ADA Curb Ramp New Construction Inspection Form (Parallel)

NW 307th

23885.56

Eggiman Ct

PARALLEL RAMP (PL)

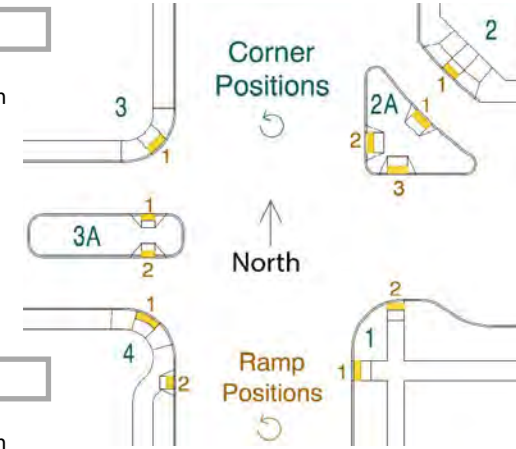
Pass	Fail
Running Slope 1	0.9 \leq 2.0%	<input checked="" type="checkbox"/> $>$ 2.0%	<input type="checkbox"/>
Cross Slope 1	2.7 \leq 2.0%	<input type="checkbox"/> $>$ 2.0%	<input checked="" type="checkbox"/>
Detectable Warning	<input type="checkbox"/> Y <input type="checkbox"/> N	<input type="checkbox"/>	<input checked="" type="checkbox"/>
Lip Height	<input type="checkbox"/> \leq 1/4"	<input checked="" type="checkbox"/> $>$ 1/4"	<input type="checkbox"/>
Gutter Flow Slope	1.2 \leq *	<input checked="" type="checkbox"/> $>$ *	<input type="checkbox"/>
Curb Running Slope (avg)	<input type="checkbox"/> 0.8 \leq 8.3%	<input checked="" type="checkbox"/> $>$ 8.3%	<input type="checkbox"/>
Counter Slope (+/-)*2	5.8 \leq 5.0%	<input checked="" type="checkbox"/> $>$ 5.0%	<input type="checkbox"/>
Det. warning full width of ramp	<input type="checkbox"/> Y <input type="checkbox"/> N	<input type="checkbox"/>	<input type="checkbox"/>

Pass	Fail
Running Slope 2	8.5 \leq 8.3%	<input type="checkbox"/> $>$ 8.3%	<input checked="" type="checkbox"/>
Length 2	4.2		
Cross Slope 2	0.8 \leq 2.0%	<input checked="" type="checkbox"/> $>$ 2.0%	<input type="checkbox"/>

Poor craftsmanship, RR2, IITD
